PRODUCT CHANGE NOTICE

**Alternate Material Set for
Assembly of the Listed
Intersil ISL8800* SOT23
Packaged Products**

**Refer to:
PCN11006**

Date: April 4, 2011

PCN11006 - Package Outline Drawing Updates

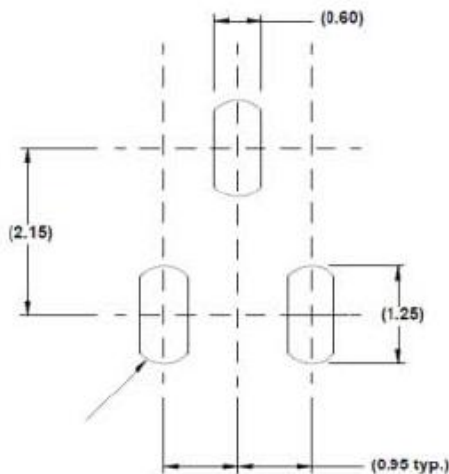
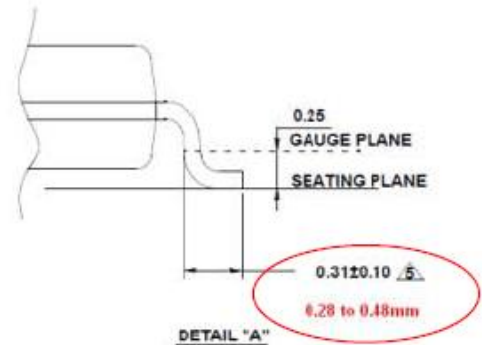
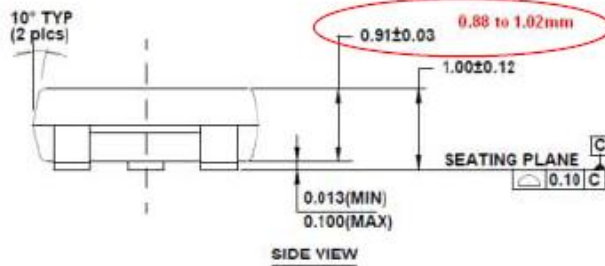
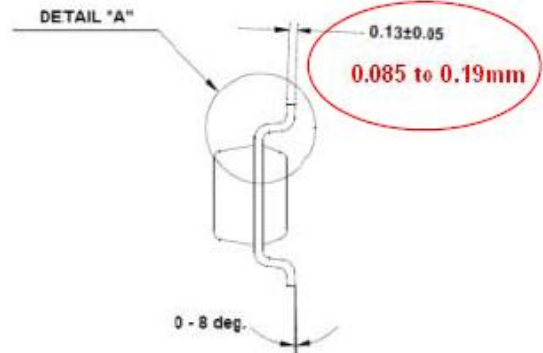
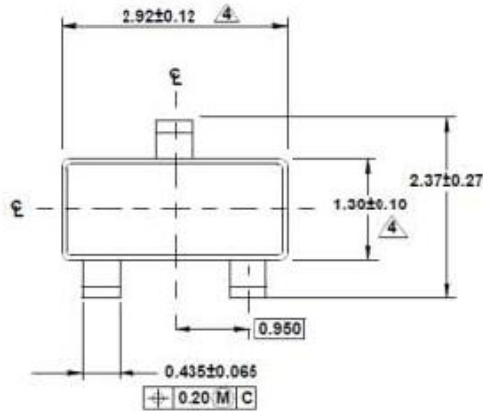
The Carsem (CAM) facility is ISO 9001:2008 and ISO/TS 16949:2009 certified and currently qualified as a supplier to Intersil for assembly of SOT23 packaged products using both the current and new material set. The package outline drawing (POD) will require minor changes to three dimensions and is included for reference. There will be no change in the moisture sensitivity level (MSL). The qualified material set combinations are as follows:
